# Eastern Creek Business Hub

Modification to allow vehicles to exit Lot 2 via the  
roundabout

State Significant Development Modification Assessment  
(SSD 5175 MOD 7 and SSD 8588 MOD 4)

Published by the NSW Department of Planning, Industry and Environment

**Figure 6 | Current vehicle access to Lot 2, entry only from the roundabout**

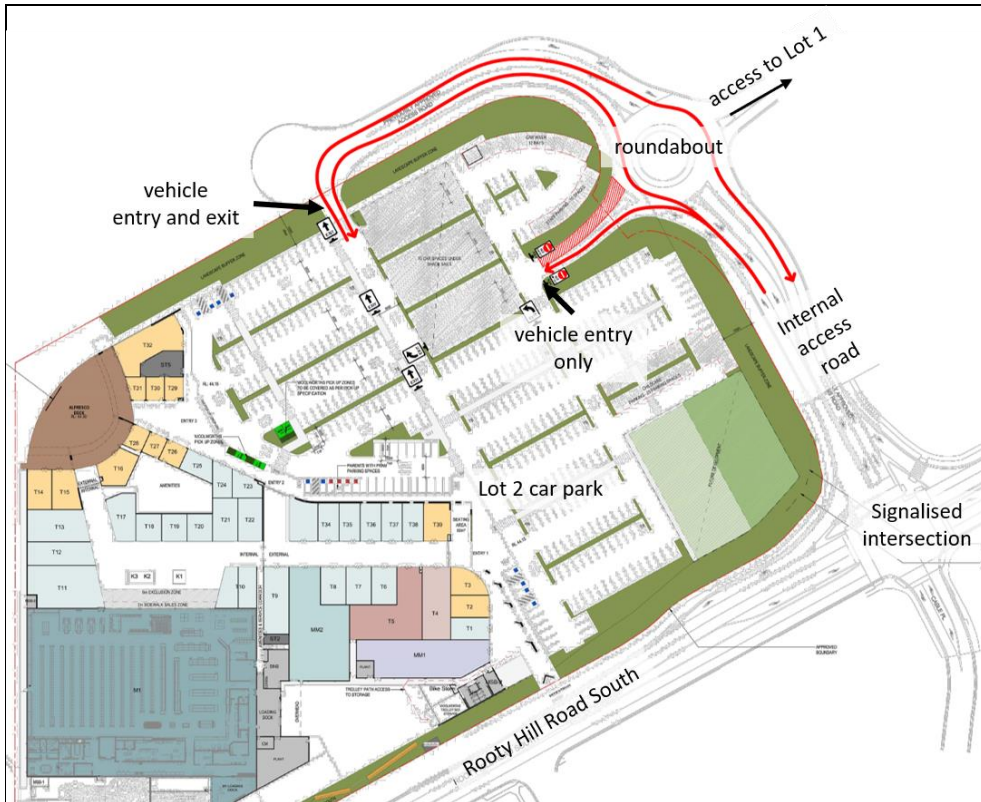
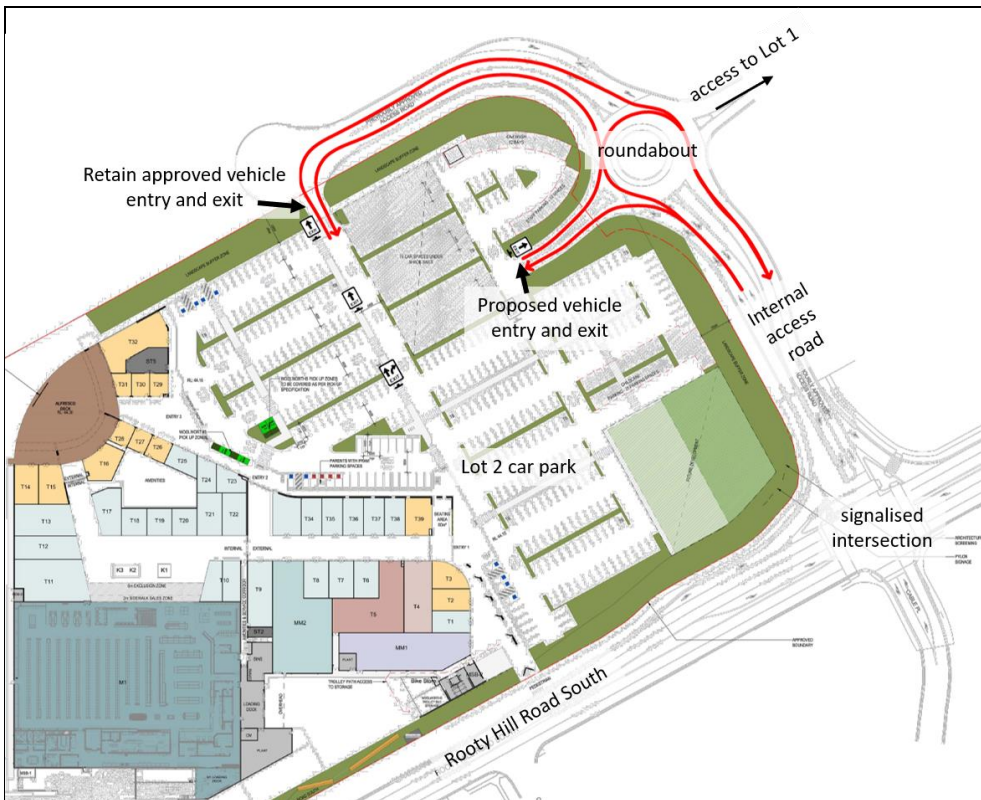
Transport for NSW (TfNSW)	
Modification Report	<ul style="list-style-type: none"><li>• On 21 November 2019, TfNSW advised it does not support the proposed modification to allow entry and exit to Lot 2 from the roundabout until Lot 3 is operational as it is concerned the design of the roundabout may impact the functioning of the RHRS/ Cable Place intersection</li><li>• On 4 December 2019, TfNSW provided further advice identifying their key concerns relating to driver behaviour and enforcement of a condition for future work.</li></ul>
RtS	<ul style="list-style-type: none"><li>• On 24 January 2020, TfNSW advised that it maintained its previous position and does not support the proposed modification</li><li>• On 17 March 2020, following a meeting between the Department and TfNSW, TfNSW further advised:<ul style="list-style-type: none"><li>○ the Applicant has not demonstrated that there is a need for the exit at the roundabout</li><li>○ the traffic modelling shows that the proposed access at the roundabout will ultimately have an impact on the signalised intersection due to queuing</li></ul></li></ul>

<ul style="list-style-type: none"> <li>○ it will be difficult to remove the exit at the roundabout once the tenant moves in because they will be used to this exit</li> <li>○ it would prefer the tenant to operate for a 12 month period to allow observation of how the approved entry/ exit points operate to determine whether there is a need for the proposed exit at the roundabout.</li> </ul>
<p>Additional Information 1</p>	<ul style="list-style-type: none"> <li>● On 31 March 2020, TfNSW reviewed the additional information submitted by the Applicant and provided the following comments: <ul style="list-style-type: none"> <li>○ adequate justification for the proposed egress at the roundabout has not been provided</li> <li>○ it is unclear if there is land available to upgrade the internal access road from two lanes to three lanes</li> <li>○ a concept civil plan, concept Traffic Signal Plan and swept plan path are requested for review.</li> </ul> </li> </ul>

The Department notes exit movements were prohibited in response to concerns raised by TfNSW, that the exiting vehicles would cause queuing back to the signalised intersection at RHRS, and adversely impact the operation of the intersection.

<p>Additional Information 2</p>	<ul style="list-style-type: none"> <li>● On 16 June 2020, TfNSW advised that it raises no objections to vehicles exiting Lot 2 via the roundabout subject to the proposed third lane on the internal access road and the following requirements: <ul style="list-style-type: none"> <li>○ the third lane on the internal access road is to be constructed prior to any occupation certificate being issued for Lot 3</li> <li>○ the Applicant will need to enter into a Works Authorisation Deed with TfNSW, prior to any construction works commencing on Lot 3</li> <li>○ the Lot 3 application will need to seek approval for the construction of the third lane from TfNSW, in accordance with section 87 of the Roads Act 1993 (and include the submitted traffic control signal (TCS) plan, civil plans swept paths and updated SIDRA traffic modelling)</li> <li>○ the land required to accommodate the third lane on the internal access road will need to be preserved as part of the modification application.</li> </ul> </li> <li>● TfNSW also provided design comments on the TCS plan submitted, to be addressed as part of the Lot 3 application.</li> </ul>

TfNSW has reviewed the amended proposal and raise no objections to allowing vehicles to exit Lot 2 via the roundabout, subject to construction of the third lane prior to the operation of any development on Lot 3.

The Department is satisfied the Applicant has addressed TfNSW's initial concerns about queuing on the internal access road and roundabout. The Department concludes the proposal is acceptable for the following reasons:

**Figure 8 |** Proposed three lanes on the internal access road

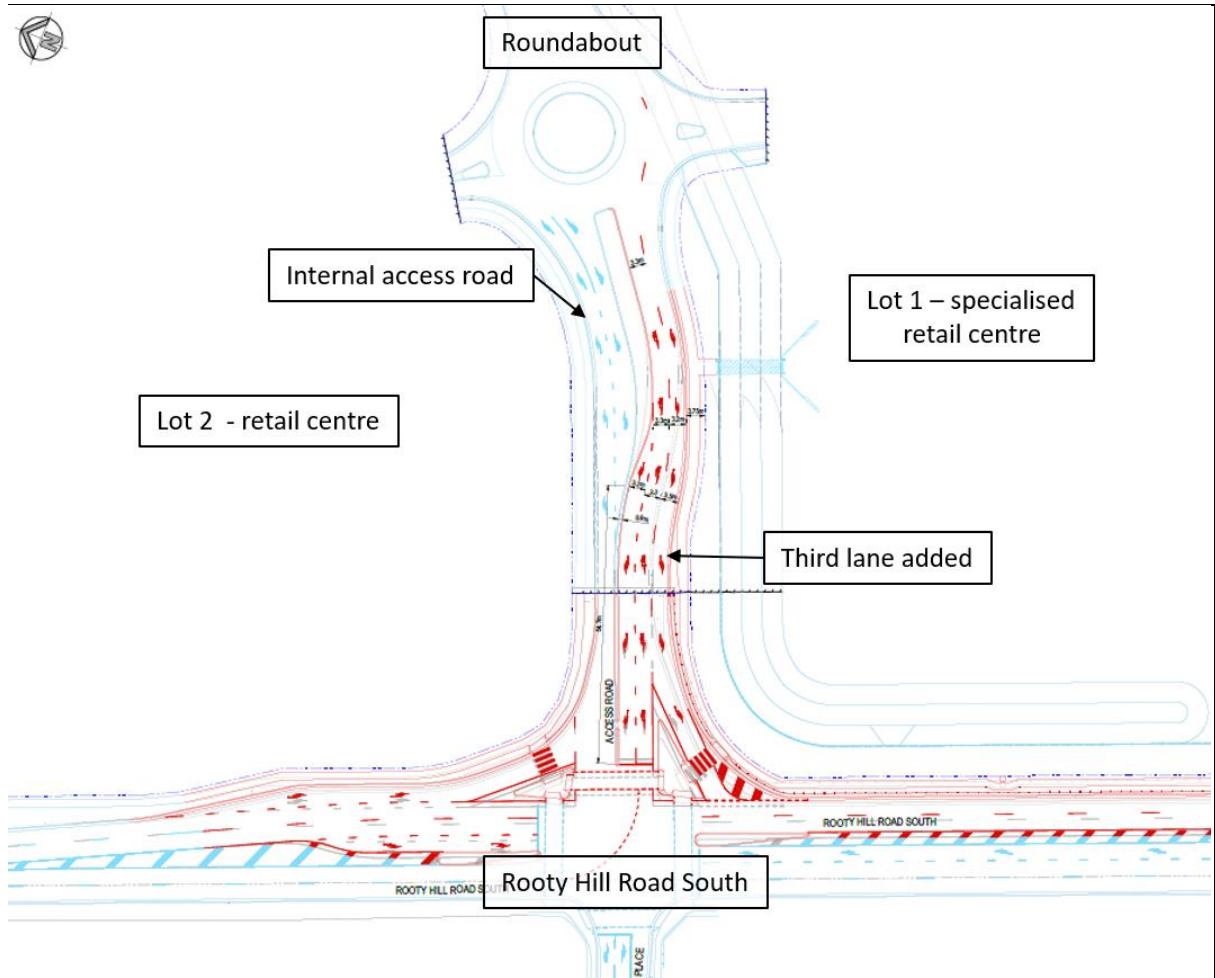
The Applicant has considered the previous concerns raised by TfNSW and proposes to upgrade the internal access road between RHR and the roundabout from two lanes to three lanes. It contends this update would increase the capacity of the internal access road and allow vehicles to exit Lot 2 without causing adverse queuing impacts. The Applicant has provided a traffic statement from CBRK which demonstrates:

- traffic generated by the approved retail centres on Lots 1 and 2 can be accommodated on the existing internal access road (two lanes) without unacceptable queuing or impacts to the roundabout or RHRS intersection
- the addition of a third lane ensures queuing would not extend back to the roundabout with traffic from lots 1, 2 and 3, noting the following:
  - the RHRS intersection would operate with average delays of 26 seconds (weekday PM) and 29 seconds (Saturday), which is a good to satisfactory level of service
  - the roundabout would operate with average delays of 11 seconds (weekday PM) and 12 seconds (Saturday), which is a good level of service.

The Department recommends a new condition be imposed on the Concept Approval to ensure that the future development application for Lot 3 includes details of the upgrade of the internal access road to three lanes, and that the upgrade is constructed prior to issue of any Occupation Certificate for the future development on Lot 3.

Issue	Findings	Recommend Condition
<b>Land for third lane</b>	<ul style="list-style-type: none"><li>TfNSW commented that the land required to accommodate the third lane on the internal access road will need to be preserved as part of this modification application.</li><li>The Department notes the concept intersection layout plans demonstrate that there is space available for a third lane within the road reserve.</li><li>The Department recommends the concept intersection layout showing the third lane be referenced in Condition B7.</li></ul>	The Department recommends Condition B7 reference the concept intersection layout supported by TfNSW.
